CONSTRUCTION – PHASE 2

**NEW CENTER FOR EMERGENCY SERVICES  
25 ROCKY HOLLOW ROAD  
NORTH STONINGTON, CT 06359**

S/P+A PROJECT NO. 13.220

**DATE: February 23, 2017**

- GROUND PLATE DETAIL TO BE USED ONLY IF 10 FT. GROUND ROD DEPTH CANNOT BE ACHIEVED DUE TO LEDGE CONDITION OR IF EXISTING TOWER FOUNDATION IS ENCOUNTERED.

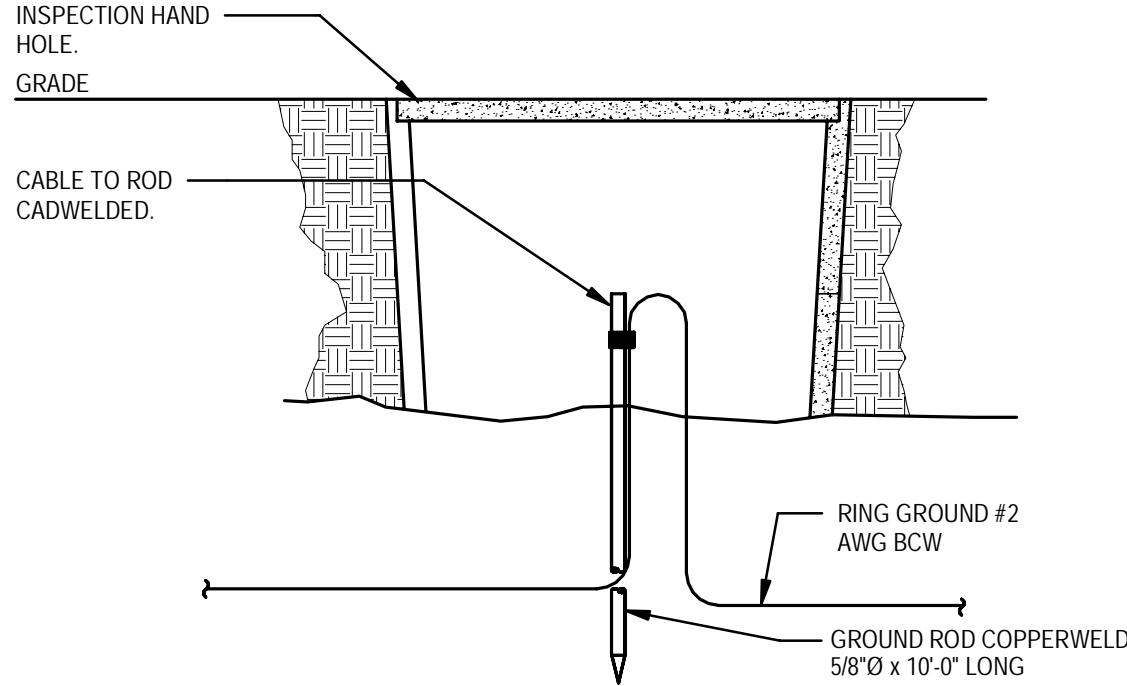
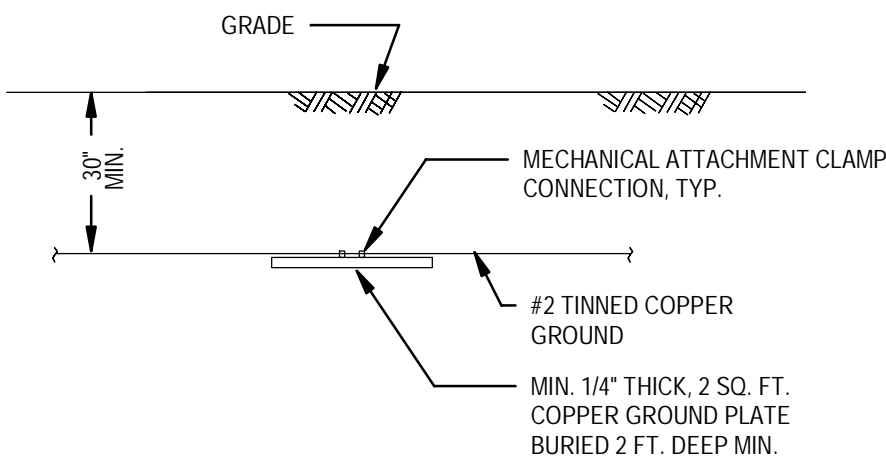
- The following CIVIL drawings (2) have been added and are attached as part of this addendum.^
  - SSK-1, FOUNDATION & DETAILS (TOWER)
  - ESK-1, SCHEMATIC & NOTES (TOWER)
- The following ARCHITECTURAL sketches (2) have been added and are attached as part of this addendum.
  - SKA1A, ADDENDUM #1 – DETAIL AT STONE BASE. This sketch revises Detail B on Drawing A9.0.
  - SKA1B, ADDENDUM #1 – STONE BASE DTL – END WALL. This sketch revises Detail C on Drawing A9.0.
